Online Open House No. 2 Summary Report

**Warden Avenue and Kennedy Road
Environmental Assessment Studies between
Major Mackenzie Drive and Elgin Mills Road in
the City of Markham**

**The Regional Municipality of York
17250 Yonge Street
Newmarket ON L3Y 6Z1**

**May 2023
300052314.0000**

Preferred Design Concept - Warden Avenue - Intersections

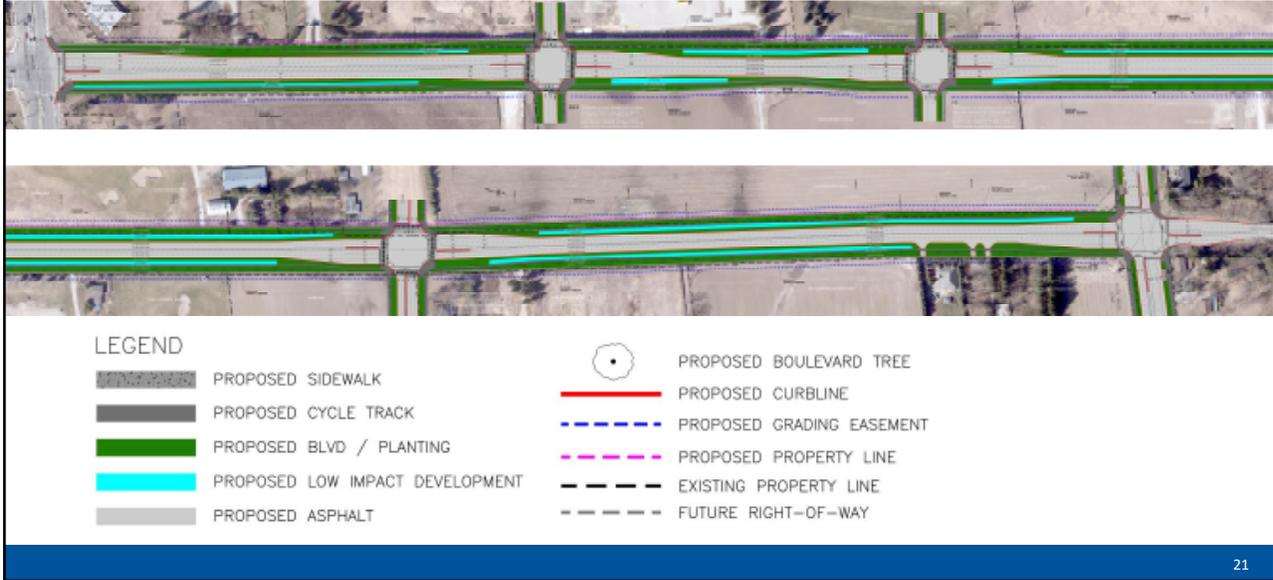
<p>Per Slides 20 and 22 of the Open House No. 2 package, the preferred intersection treatment at all five signalized intersections on each Warden Avenue and Kennedy Road is a “cross ride”. However, York Region’s Pedestrian and Cycling Planning and Design Guidelines (pages 110 to 114) discuss a preferred option; use of protected intersections with corner refuge islands. To</p>	<p>Acknowledged. The Project Team will evaluate each intersection and crossing details, balancing all user needs during the Detailed Design phase of the project.</p>

Comment	Response
quote from page 110, “The protected intersection is emerging in North America as a preferred higher order intersection treatment...” Please evaluate this concept at some or all signalized intersections.	
Although beyond the scope of this EA, York Region is encouraged to improve cycling facilities along other Regional roads and provide cycle lanes or cycle tracks, where absent. The Warden Avenue and Kennedy Road roll plans clearly illustrate glaringly absent cycling facilities beyond the EA Study Area.	The Project Team acknowledges this is beyond the scope of this EA. Connectivity and transition to existing facilities at the limits of the project is considered during Detailed Design, while also taking into consideration transition to future linkage opportunities recommended by York Region’s Transportation Master Plan and Pedestrian and Cycling Planning and Design Guidelines.
